MEMO

To: Kristopher Byrd, Well Construction and Compliance Section Manager
From: Joel Jeffery, Well Construction Program Coordinator
Subject: Review of Limited License Applications LL-1726 1728
Date: August 30, 2018

Groundwater Application Review Summary Form

TO: Water Rights Section Date 08/28/2018
 FROM: Groundwater Section Darrick E. Boschmann
Reviewer's Name
 SUBJECT: Application LL1726/LL1728 Supersedes review of N.A.
Date of Review(s)

Figure 14: Supplemental data provided by the applicant - LAKE 51059.

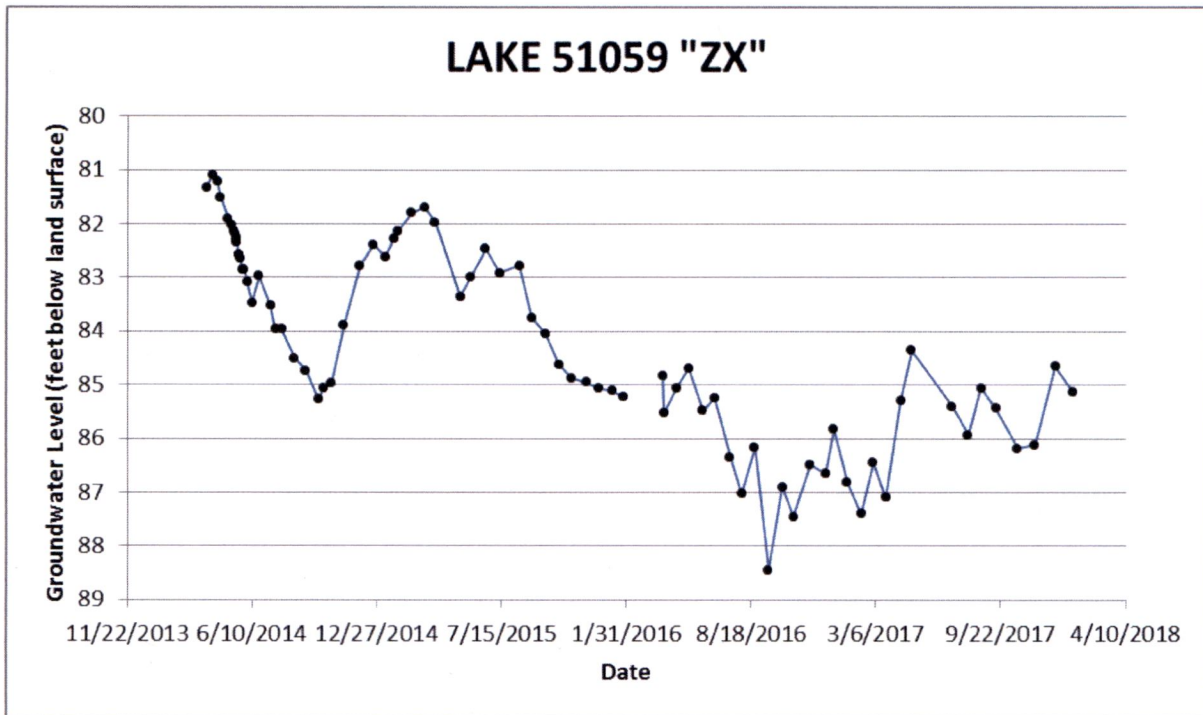
LAKE 51059 (“ZX”; unused; 1412 ft TD/78°F) has a period of record from 3/28/2014 to 1/16/2018. The hydrograph for this well indicates a decline trend from spring of 2014 through spring of 2017 of approximately 3.25 feet over the period of record; or approximately 1 ft/yr. Formation descriptions on the well log for LAKE 51059 indicate the well is completed in the volcanic rock unit.
